## Response to Spokes'

NDDG Fortnightly Meeting  
April 17 2019  
James Sinclair, LHEP

# Questions from the Spokes

# Reducing Overall Detector Dimensions

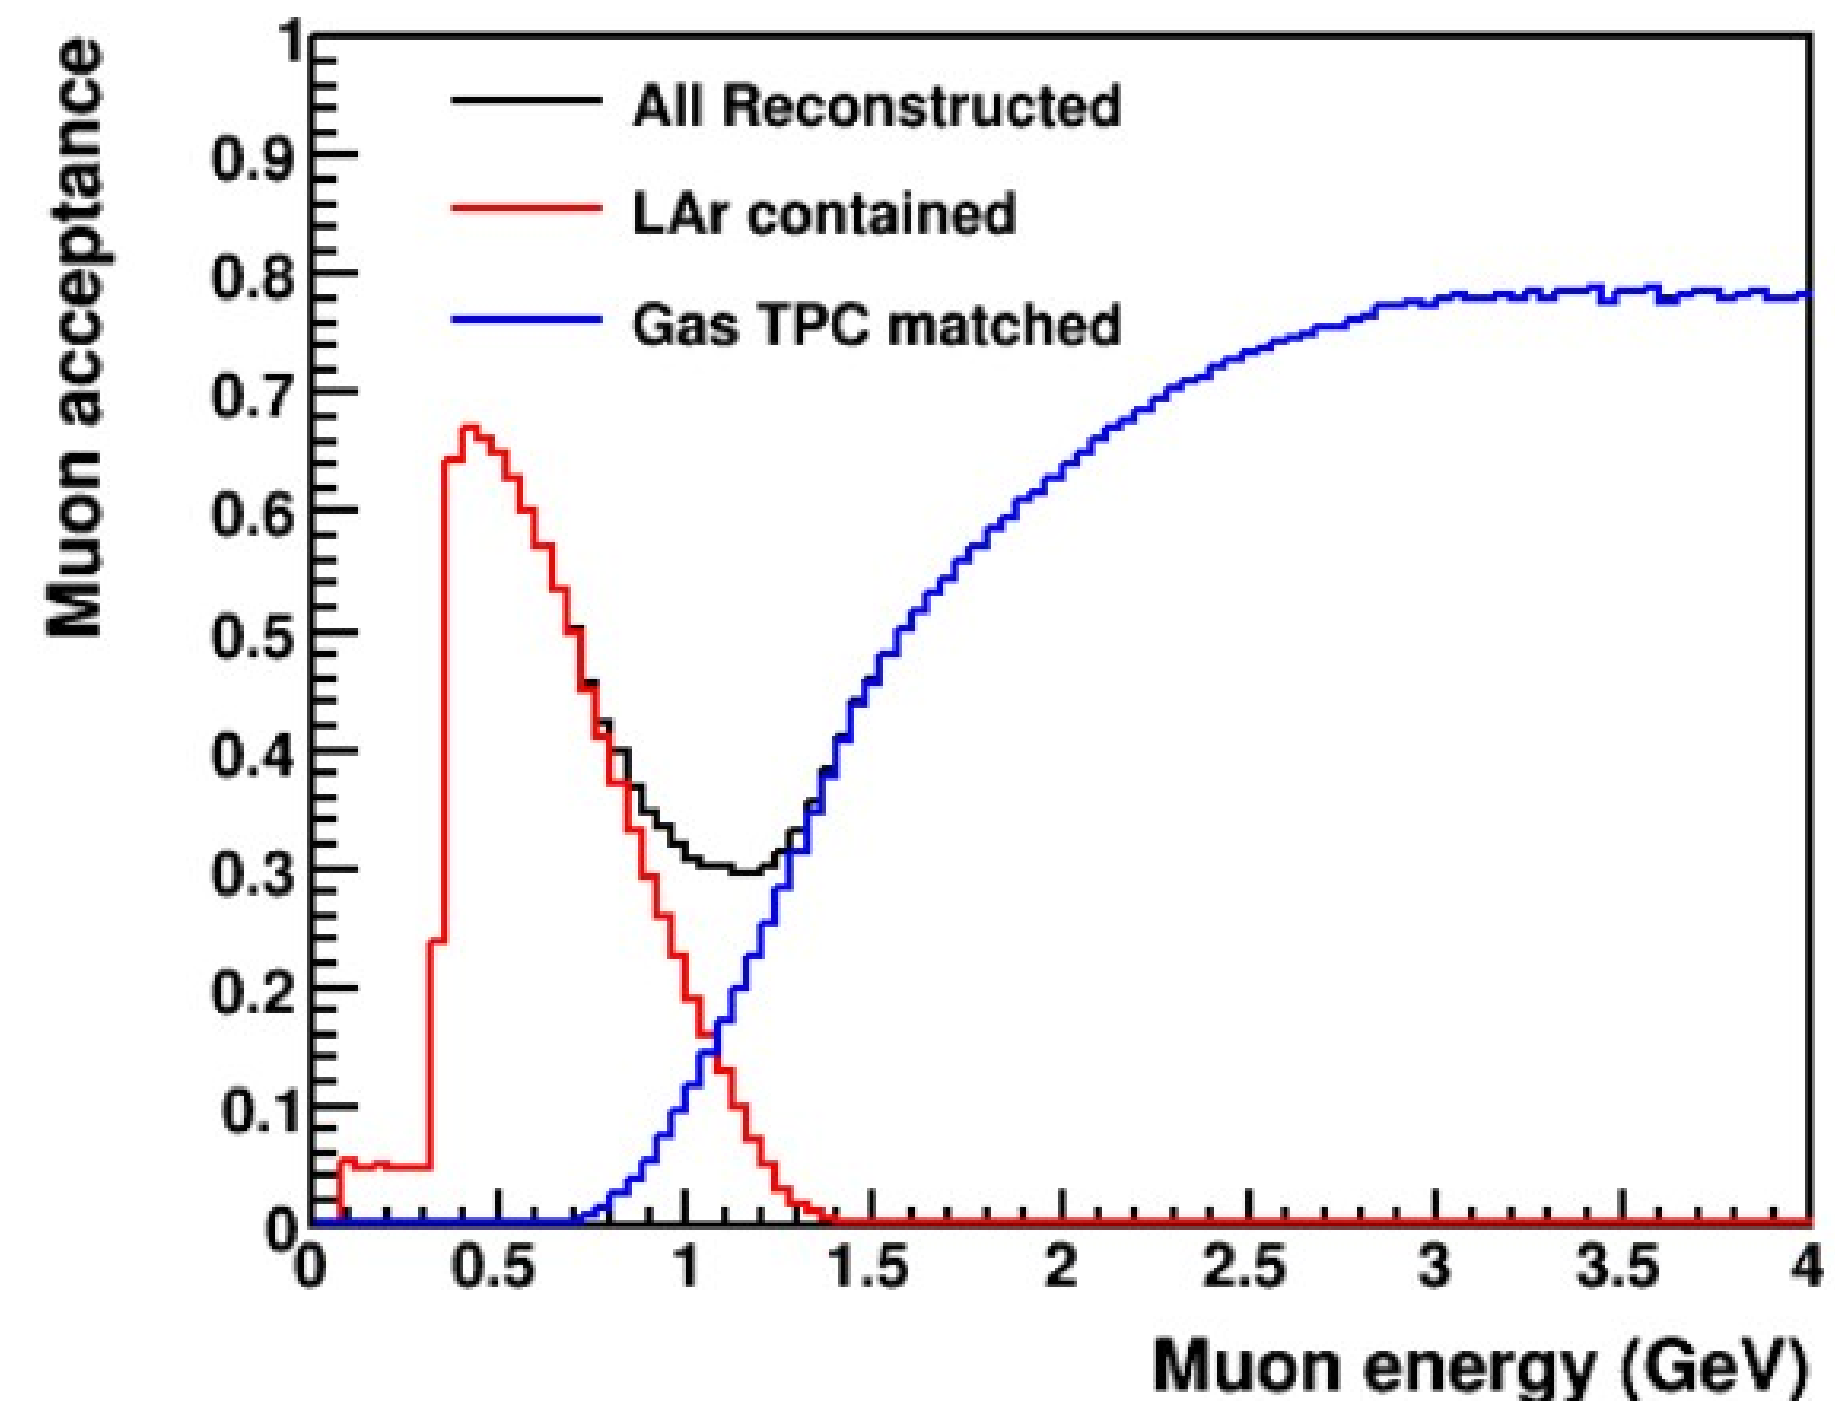
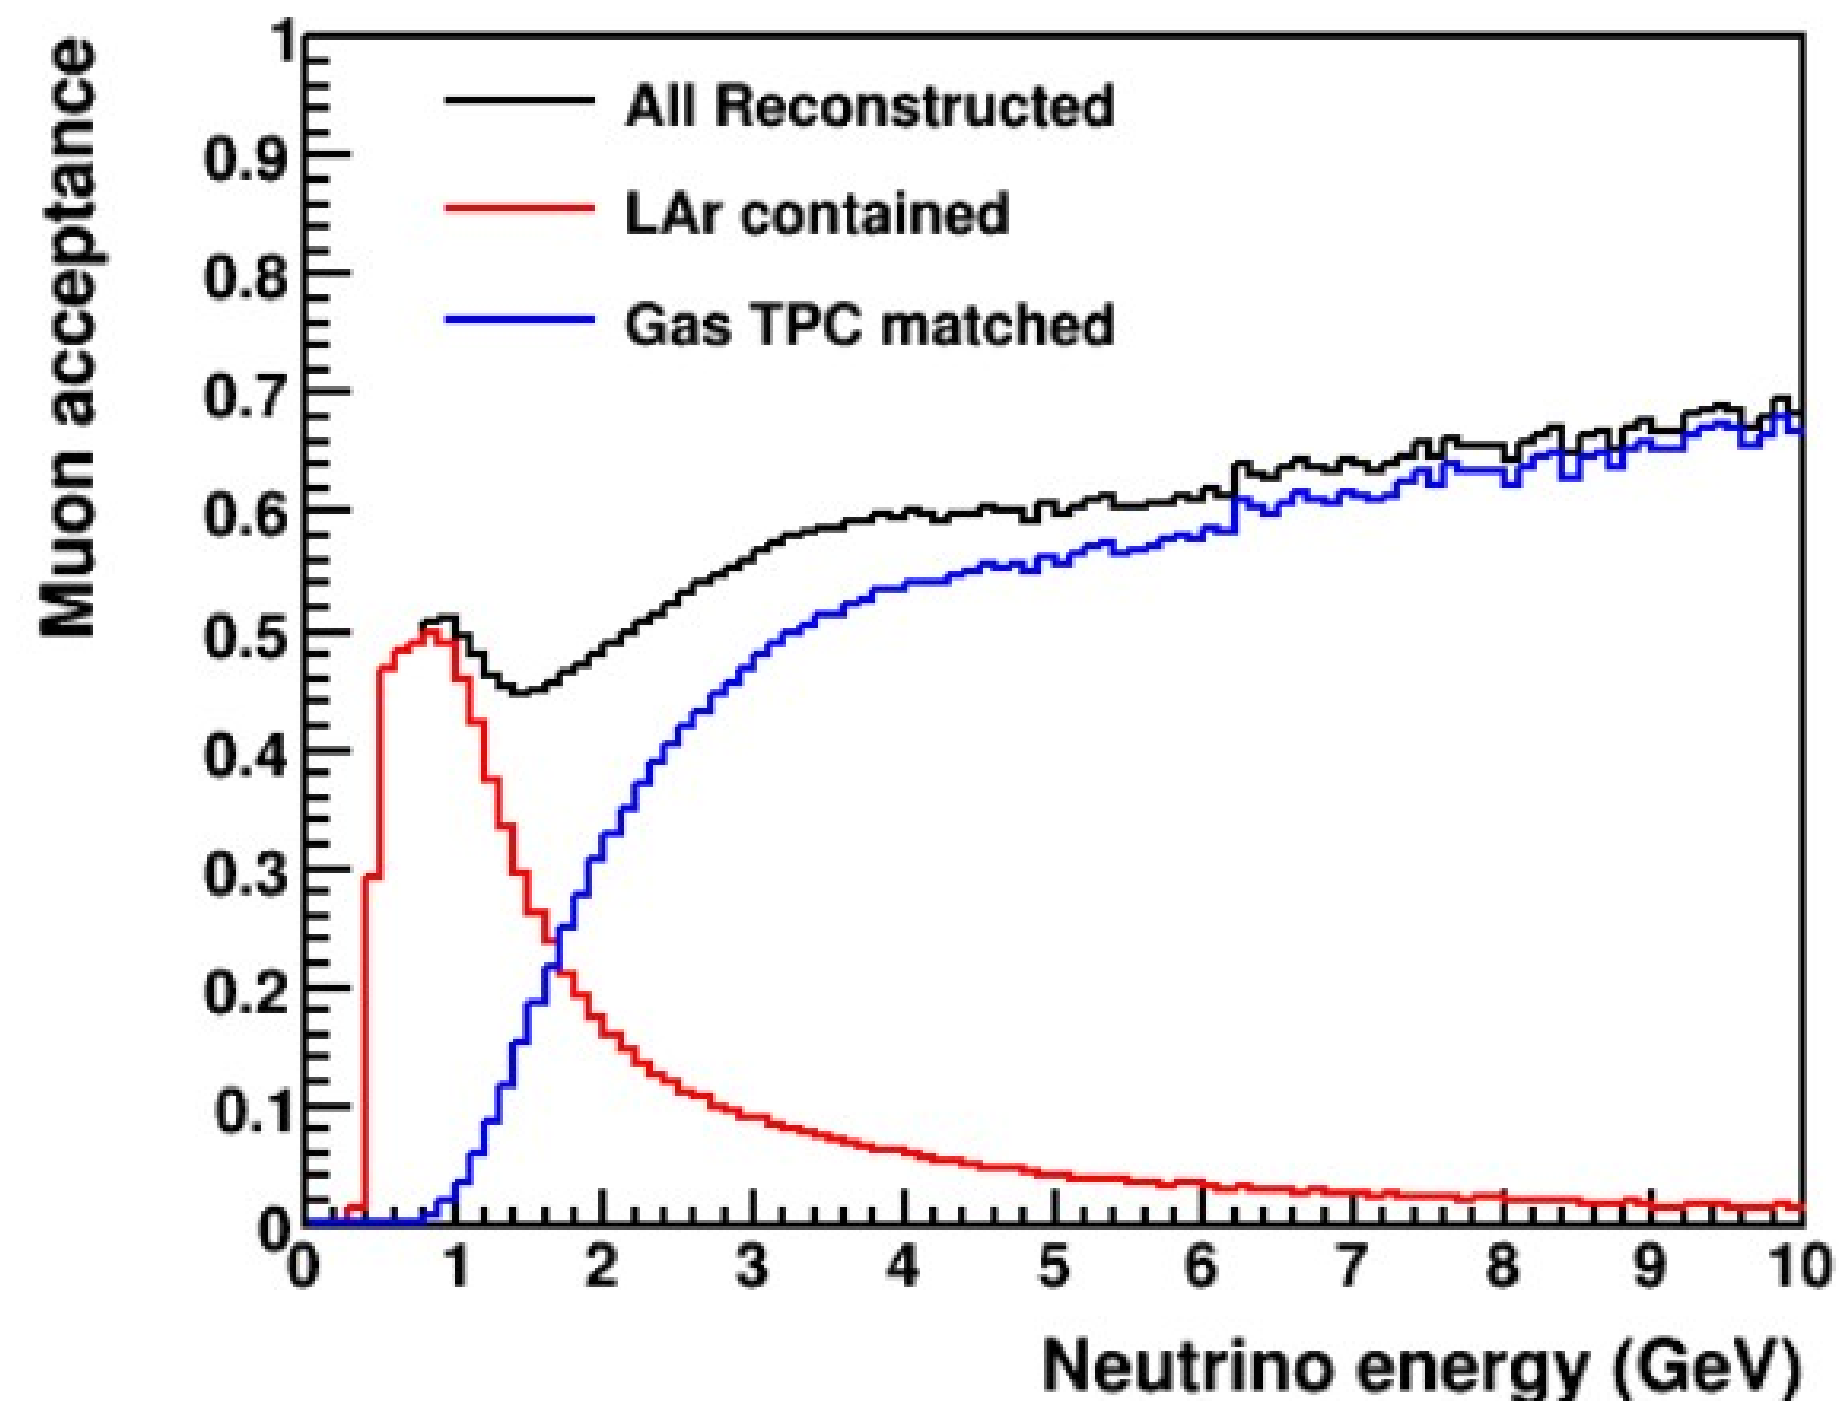
Also important to consider muons. Muons can be measured when they stop in ArgonCube or when they pass into the spectrometer. Muons that stop between the two regions cannot be reconstructed accurately. **ArgonCube must be long enough so that there is no hole in the acceptance as a function of muon momentum.**
